REPORT ON PROPOSALS

THE WATER EFFICIENCY AND SANITATION STANDARD
TECHNICAL COMMITTEE REPORT ON PROPOSALS FOR
PUBLIC REVIEW AND COMMENT

These proposals were presented to the WE•Stand Technical Committee members who met in Ontario, California on June 22-23, 2022.

FIGURE E 104.1
ONSITE WASTEWATER TREATMENT STAGES FOR DPR

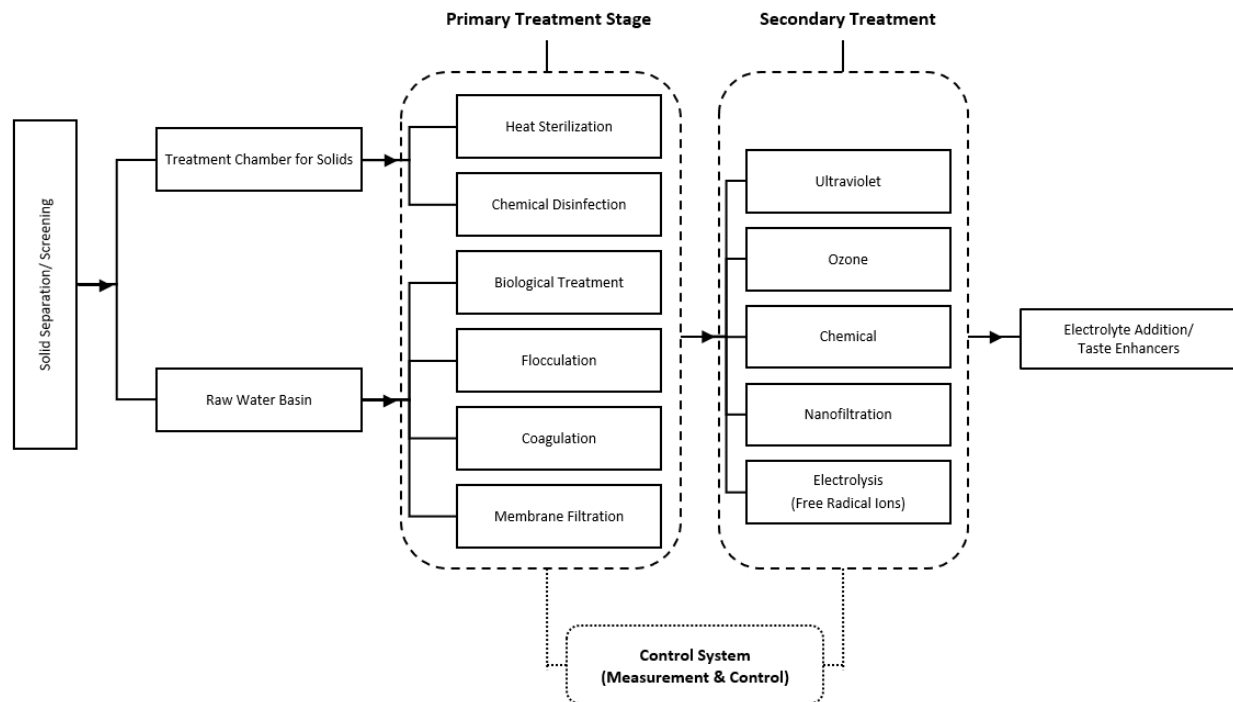
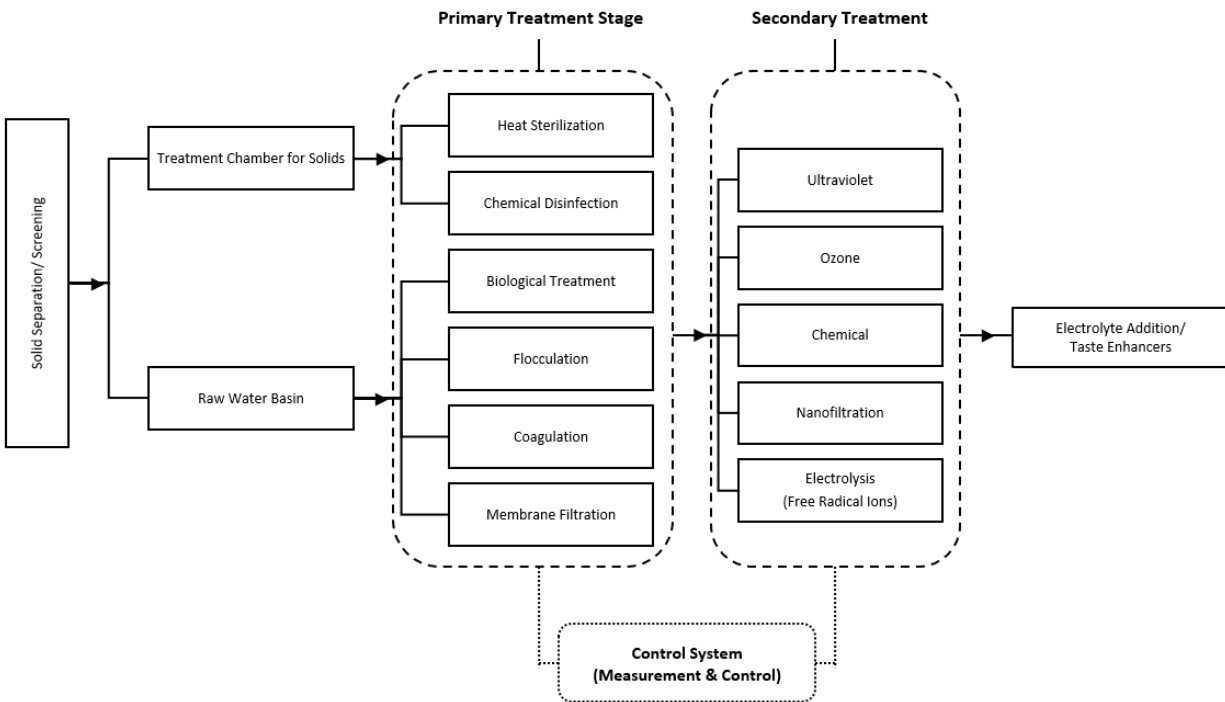
The primary treatment stage includes sterilization via heat, chemical disinfection, biological treatment, flocculation, coagulation, or membrane filtration. A means of secondary treatment is then required to further purify the wastewater through additional processes listed in Section E 104.4. Each of these treatment types are supported by definitions proposed in previous items by this Task Group. Figure E 104.1 also serves as a process flow diagram of the required treatment stages. Overall the layout of the section clearly states the needed treatment stages and appropriate methods of completing such treatment to ensure water quality and safety.

FIGURE F 301.1(1)
GRAY WATER DRAINAGE SYSTEM- DIVERTER VALVE IN CRAWL SPACE

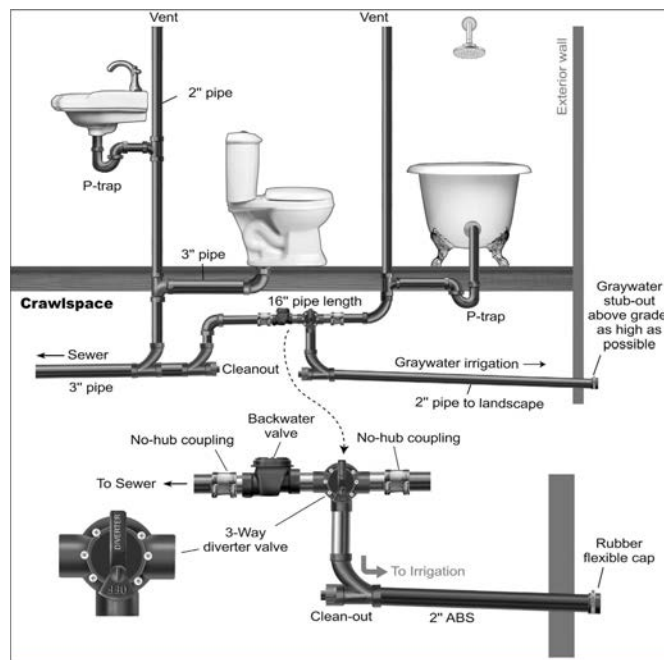
Figure F 301.1(1) illustrates graywater being collected from a first-floor shower/bath, with the diverter valve located in the crawlspace or basement.

FIGURE F 301.1(2)_
GRAY WATER DRAINAGE SYSTEM – SINGLE FIXTURE ON SECOND FLOOR NEAR EXTERIOR WALL

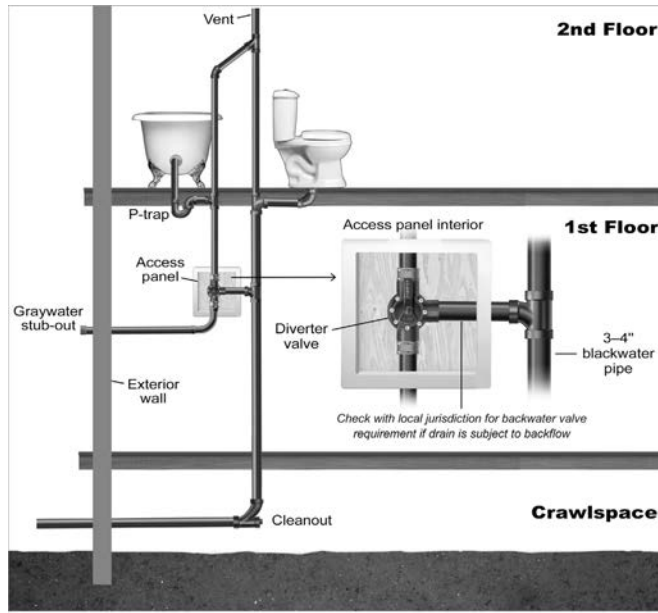
Figure F 301.1(2) shows graywater being collected from a second-story shower/bath, with the diverter valve located below the bathroom inside the wall of the first floor.

FIGURE F 301.1(3)_
GRAY WATER DRAINAGE SYSTEM – SINGLE FIXTURE ON SECOND FLOOR WITH STUB-OUT ABOVE GRADE, FROM CRAWL SPACE UNDER THE FIRST FLOOR

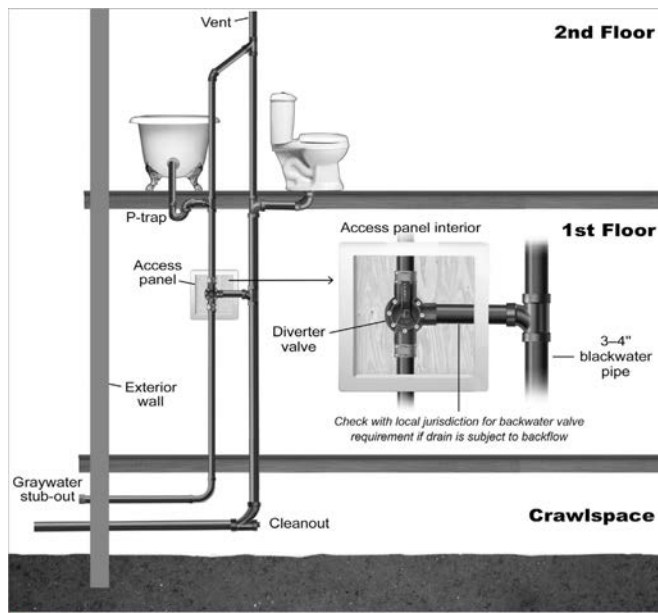
Figure F 301.1(3) shows the same plumbing set-up as installed in Figure F 301.1(2), except the shower/bath drain pipe runs through the first floor and into the crawlspace. The graywater stub-out is located outside of the exterior crawl space foundation wall or crawl space vent, above grade. This configuration may be applicable when fixtures are located in the interior of the building and a stub-out can't be piped easily through an exterior wall above floor level.

**FIGURE F 301.1(4).
GRAY WATER DRAINAGE SYSTEM – MULTIPLE FIXTURES ON CONCRETE SLAB FOUNDATION**

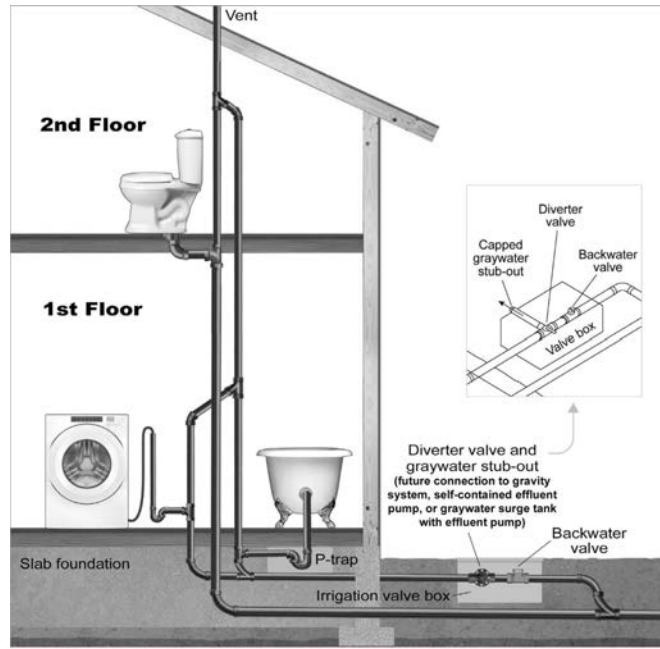
Figure F 301.1(4) shows graywater diversion from the shower/bath and clothes washing machine in a house with a slab-on-grade foundation, where the diverter valve is located outside the building envelope in a subsurface enclosure (i.e., an irrigation valve box). The subsurface enclosure containing the diverter valve needs to be permanently accessible (i.e., no structures or hardscape covering it). The diverter valve should be positioned as high as possible in the enclosure to ensure graywater can drain at a 1/4 inch per 12 inch slope into a future gravity irrigation system or pump basin.

**FIGURE F 301.1(5).
GRAY WATER DRAINAGE SYSTEM – GRAYWATER PIPING EXTENDS OUTSIDE SLAB FOR ACCESS, THEN RETURNS INTO SLAB TO JOIN OTHER DRAINAGE PIPING**

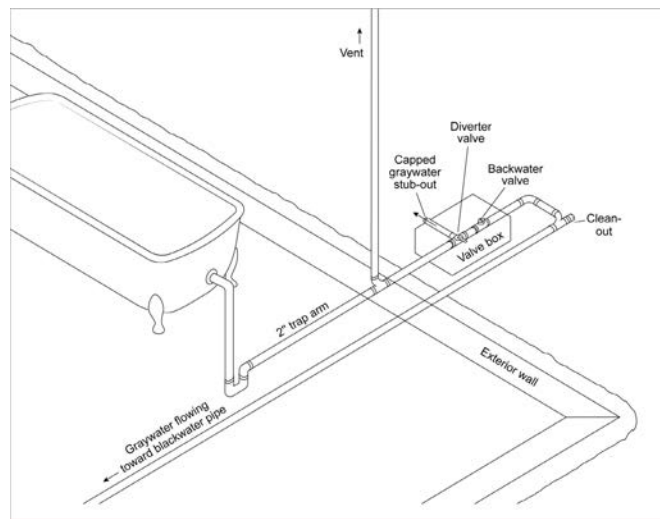
Figure F 301.1(5) demonstrates how to make graywater from a tub/shower (or other fixture) accessible when the bathroom is on a slab and the main drain is in another area of the building. The tub/shower drain has been directed through the slab and perimeter foundation to a subsurface enclosure (i.e., an irrigation valve box). A diverter valve and backwater valve are located in the box, providing a graywater stub out. The tub/shower drain then loops back through the foundation and into the slab to proceed to where it connects with the building's other drainage piping. 1/4 inch per 12 inches of slope must be carefully maintained on this loop piping

**FIGURE F 301.1(6).
GRAY WATER DRAINAGE SYSTEM – CLOTHES WASHER GRAYWATER SYSTEM WHERE GRAYWATER
IRRIGATION PIPE IS RUN THROUGH CRAWLSPACE**

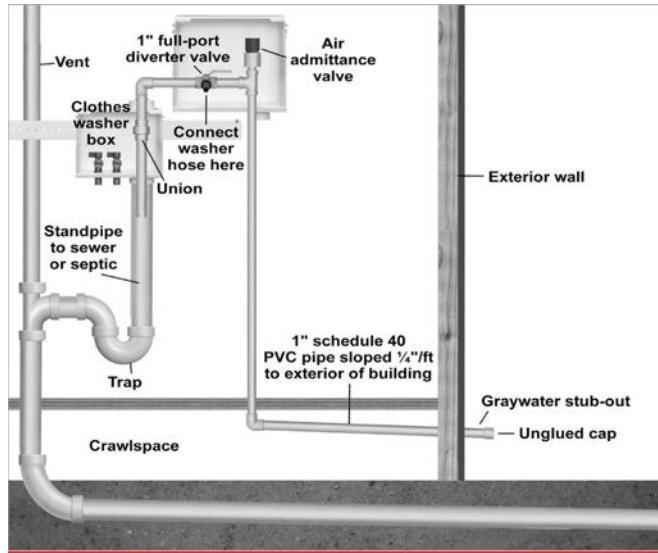
Figure F 301.1(6) illustrates laundry-to-landscape piping in a building with a crawl space.

**FIGURE F 301.1(7).
GRAY WATER DRAINAGE SYSTEM – CLOTHES WASHER GRAYWATER SYSTEM WHERE CLOTHES WASHER IS
NEAR AN EXTERIOR WALL OR ON A CONCRETE SLAB FOUNDATION**

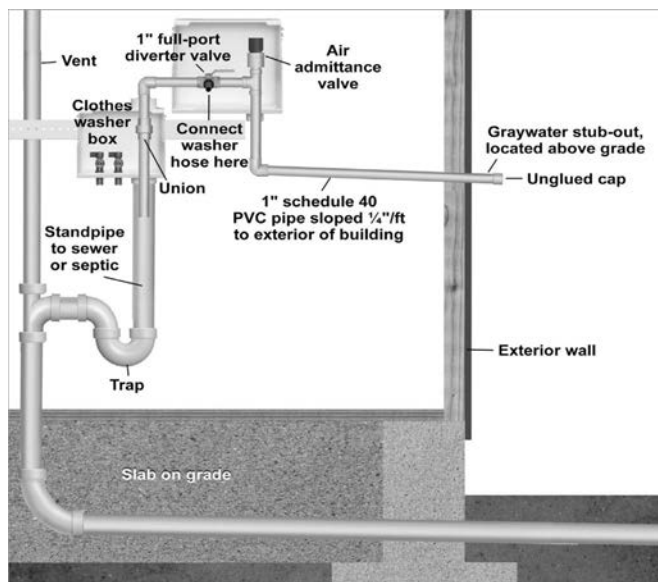
Figure F 301.1(7) illustrates laundry to landscape piping in a slab on grade building. A diverter valve is mounted to the wall in an access panel and connected directly to the discharge hose of the clothes washer.

**FIGURE F 301.1(8)
OVERVIEW OF A GRAVITY-FLOW, BRANCHED DRAIN SYSTEM**

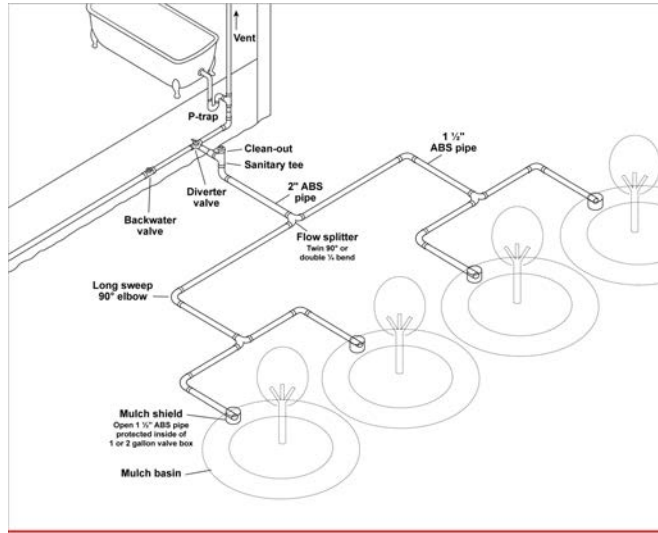
Figure F 301.1(8) demonstrates a conceptual image of how a gravity-flow, branched drain graywater system transports graywater to multiple landscape plants without a storage tank or pump.

**FIGURE F 301.1(9)
OVERVIEW OF PUMPED GRAYWATER TO IRRIGATION SYSTEM**

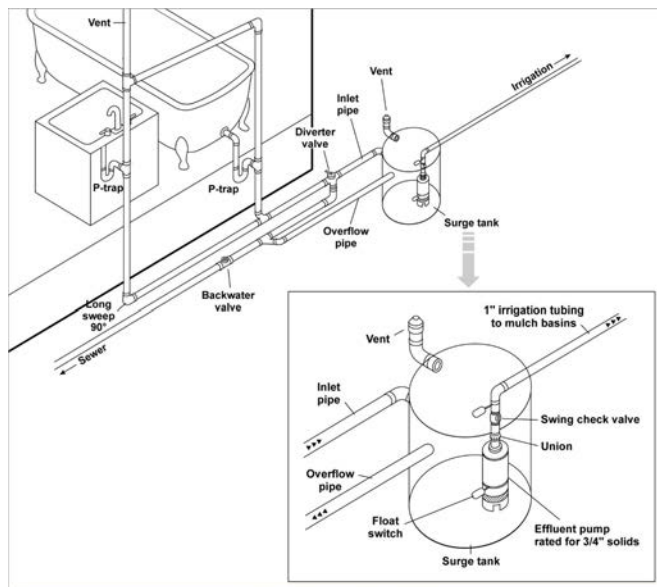
Figure F 301.1(9) shows graywater from a lavatory and tub/shower being made available for irrigation. All of figures were gathered from the Guidance on Ordinance Compliance in Illustrations which may be accessed via the following link:
https://localenergycodes.com/download/787/file_path/fieldList/CCGA%20Illustrated%20Compliance%20Guidance.pdf
